REVIEW BURIED PIPING FOR MIDLAND PLANT

Dec 16, 1981 TO NRC

MIDLAND PROJECT
NRC REQUEST FOR DETAILS OF STRESS
ANALYSES FOR UNDERGROUND PIPING
FILE: 0485.16/B1.7 UFI: 70*01 00234(S) 15100(E) SERIAL: 10113

SUMMARY OF SETTLEMENT STRESS CALCULATIONS FOR BURIED PIPING

ORIGINATOR Vincent Nguyen DATE 11-7-80 CALC. NO. 1007 REV. NO. _____
 PROJECT MIDLAND UNIT - 2 CHECKED C.F. Harrit DATE 11-7-80
 SUBJECT LINE No: 26"-2JBD-1 JOB NO. 7220 SHEET NO. _____

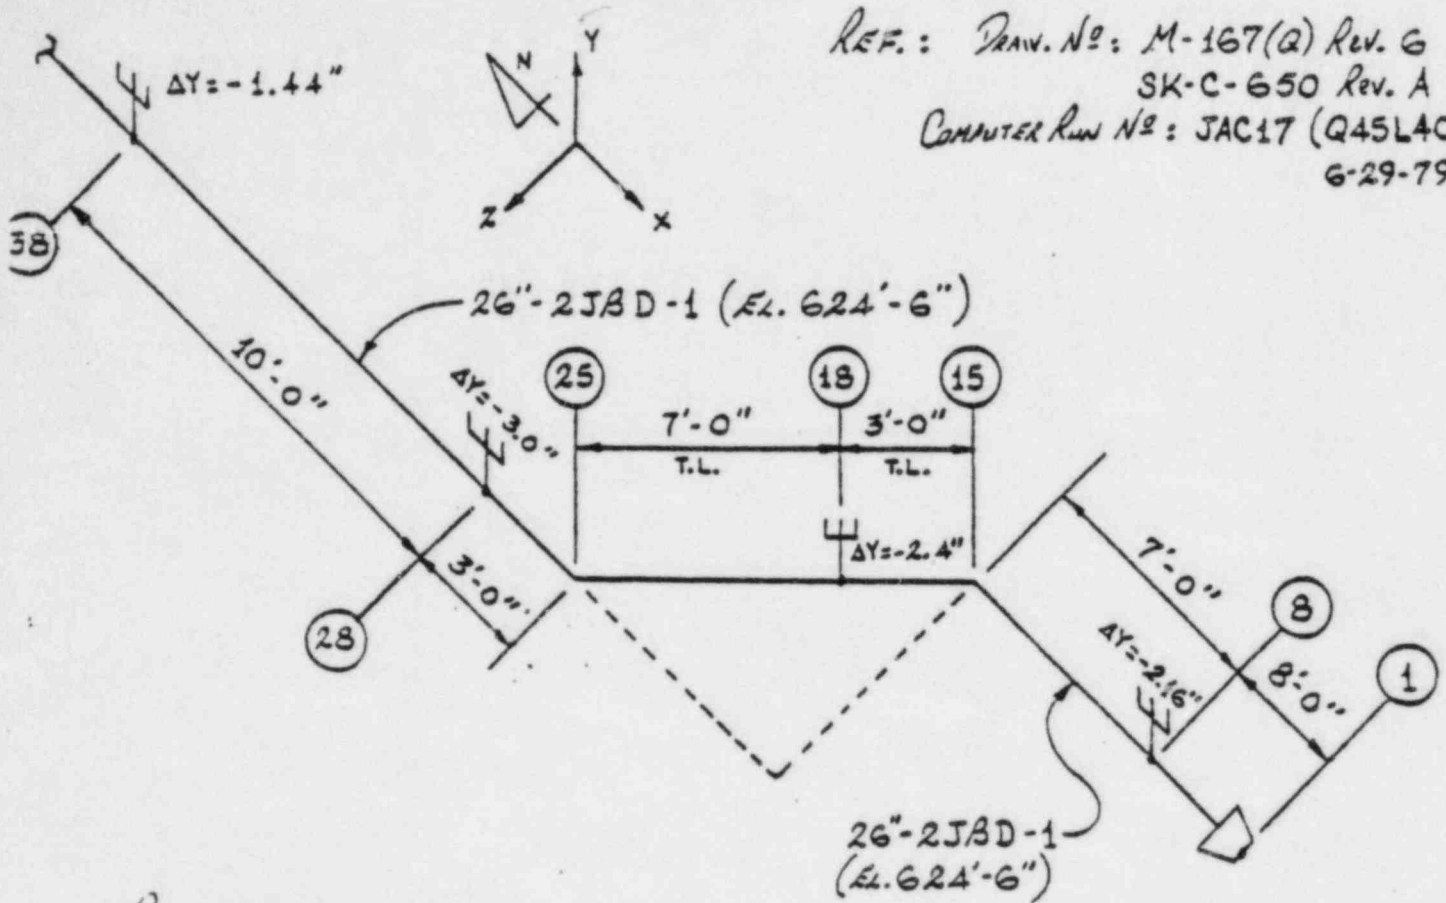
COMMENT :

1. $LB/FT = 320.10$ and NOT $LB/FT = 278.50$ as input
